Well Name: MITZI COM	Well Location: T26N / R12W / SEC 23 / SWNE / 36.4740322 / -108.0760836	County or Parish/State: SAN JUAN / NM
Well Number: 90	Type of Well: OTHER	Allottee or Tribe Name: EASTERN NAVAJO
Lease Number: NOG99091356	Unit or CA Name:	Unit or CA Number: NMNM104874
US Well Number: 300453009300S1	Operator: DUGAN PRODUCTION CORPORATION

Sundry ID: 2862934

Type of Submission: Notice of Intent	Type of Action: Plug and Abandonment
Date Sundry Submitted: 07/13/2025	Time Sundry Submitted: 03:31
Date proposed operation will begin: 07/18/2025

Notice of Intent – Plug and Abandonment

Planned P & A Wellbore Schematic

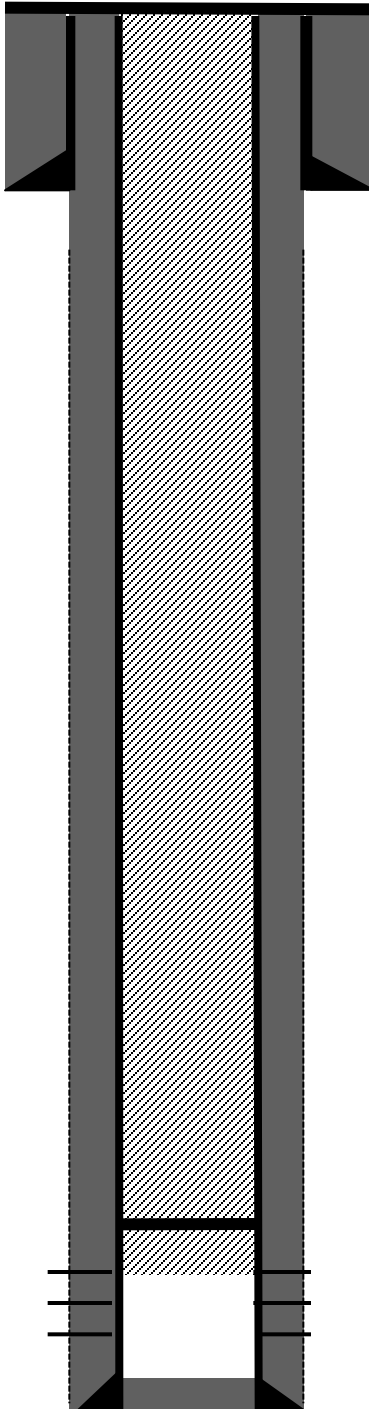
Complete wellbore fill up proposal. No changes to procedure. Limited raster log data associated to the well. Reference well supports the formation tops selected by the operator.

1. Plugging operations authorized are subject to the attached "General Requirements for Permanent Abandonment of Wells on Federal and Indian Lease."
2. The following modifications to your plugging program are to be made:
 - a. Complete wellbore fill up proposal. No changes to procedure.
3. **Notification:** Farmington Office is to be notified at least 24 hours before the plugging operations commence at (505) 564 7750.
